Rule 21 Working Group Four
Final Report
Third draft 8/3
Comments due by 8/7

Working Group Four Background

Figure 1: Risk of Islanding Study Option in the Study Process

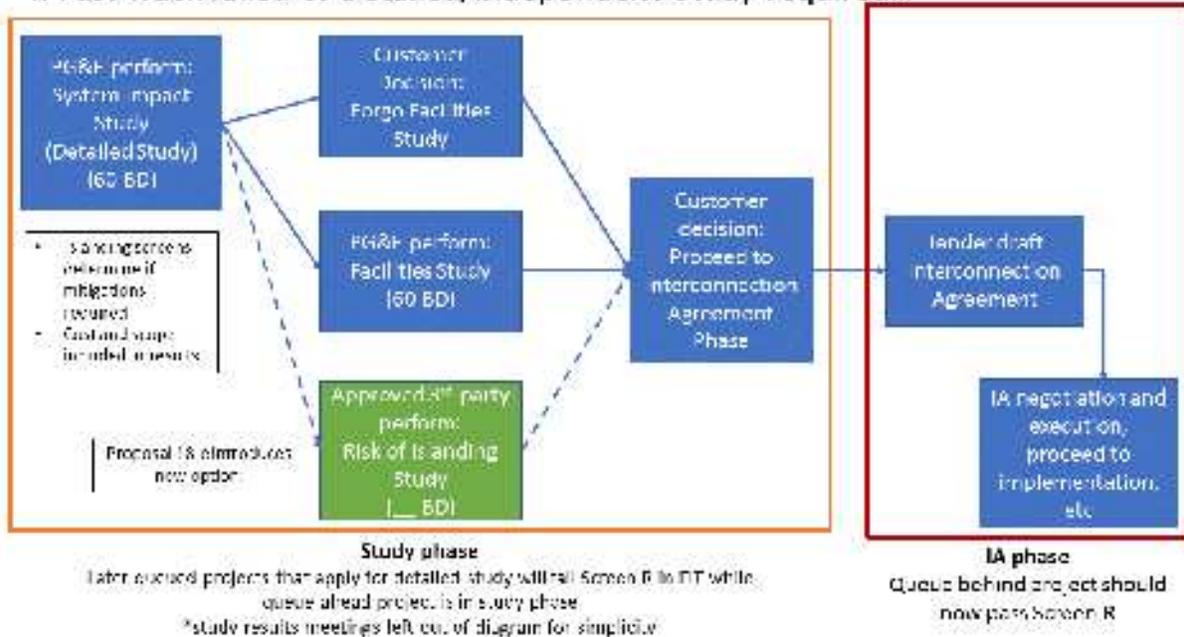
PG&E supports this proposal in that it could provide an evaluation methodology to verify the need for anti-islanding mitigation. However, PG&E points out that an risk-of-islanding study timeline is needed to ensure projects move through the study process and don't remain indefinitely. All other Rule 21 study tasks are governed by a timeline either for the customer or IOU to complete a task within a specific time and this should be no exception.

Figure-1 Certified Inverter Screen

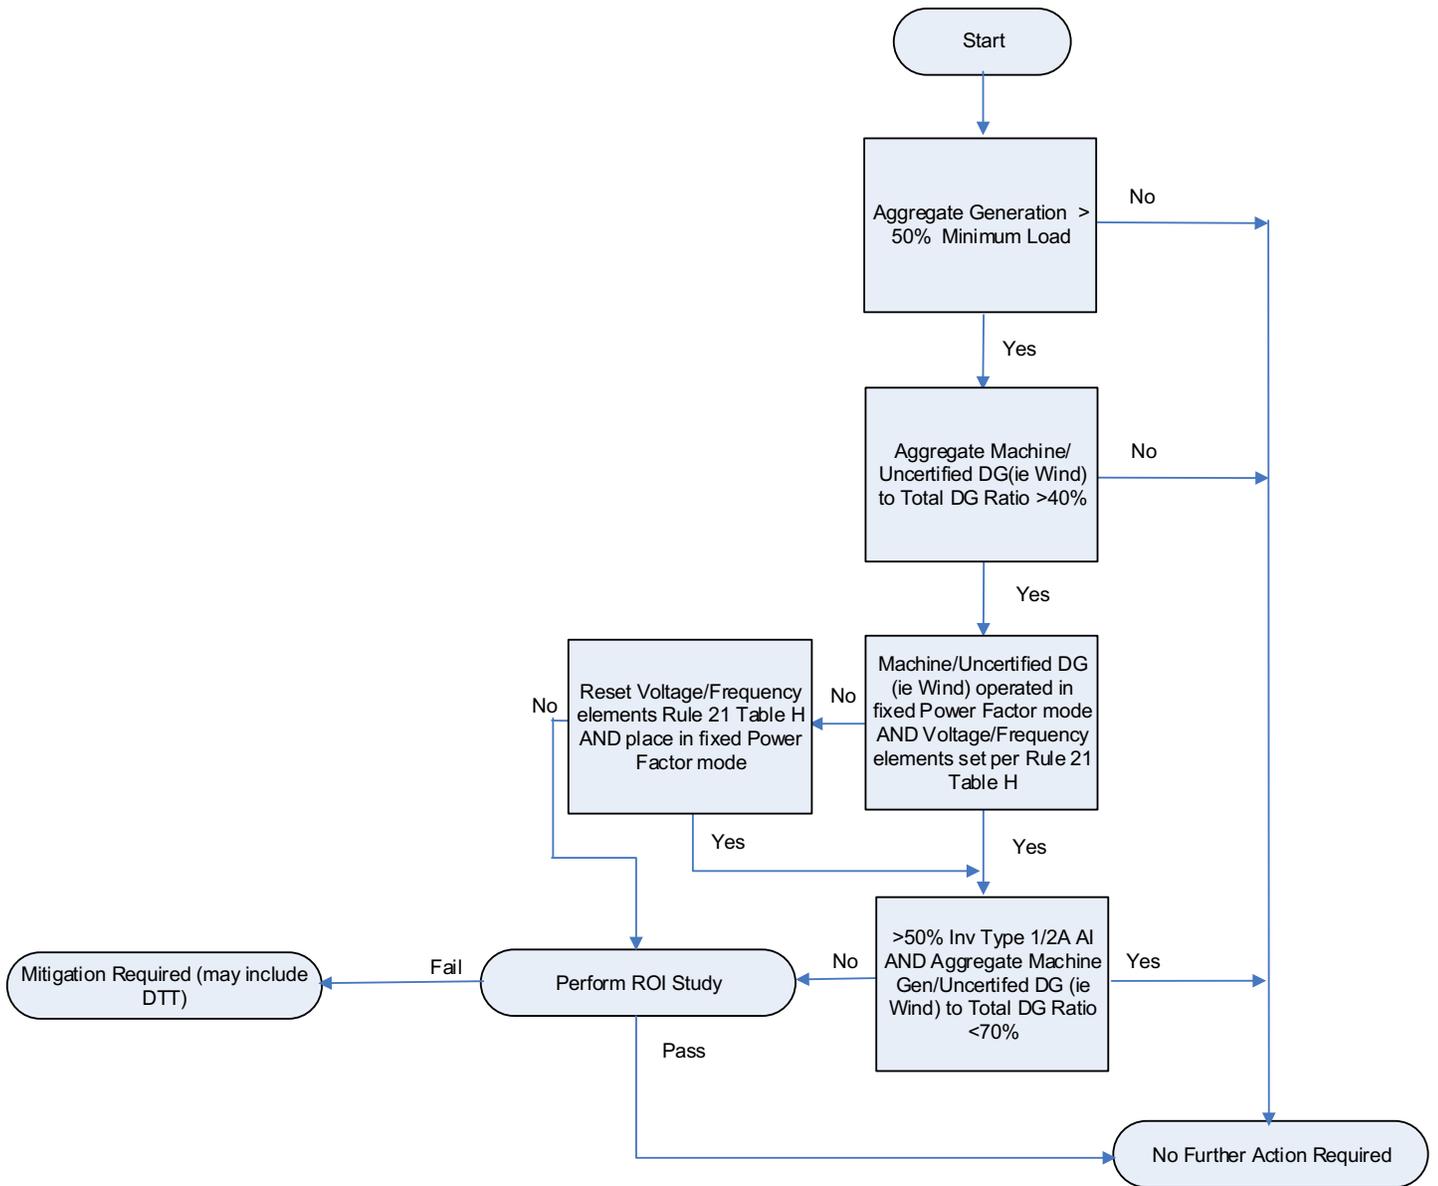
Tesla generally supports the concept behind PG&E’s proposal, which would add several additional screens to its existing study process to more narrowly apply a requirement to deploy direct transfer trip or other mitigations to those circumstances where the risk of anti-islanding failure is more likely.

Tesla does have some questions regarding the practical ability to implement PG&E’s proposal. Specifically, it seems that implementing PG&E’s approach would require knowing the anti-islanding detection algorithm that is employed by all of the existing inverters interconnected to a given circuit. The proposed screen would require that Group 1 and 2A detection types make up > 70% of the inverter population by nameplate on a given circuit to avoid a risk of islanding study. It’s unclear from PG&E’s proposal how they would acquire this information and, if they are unable to obtain it, how that would impact how this would change their proposed screens.
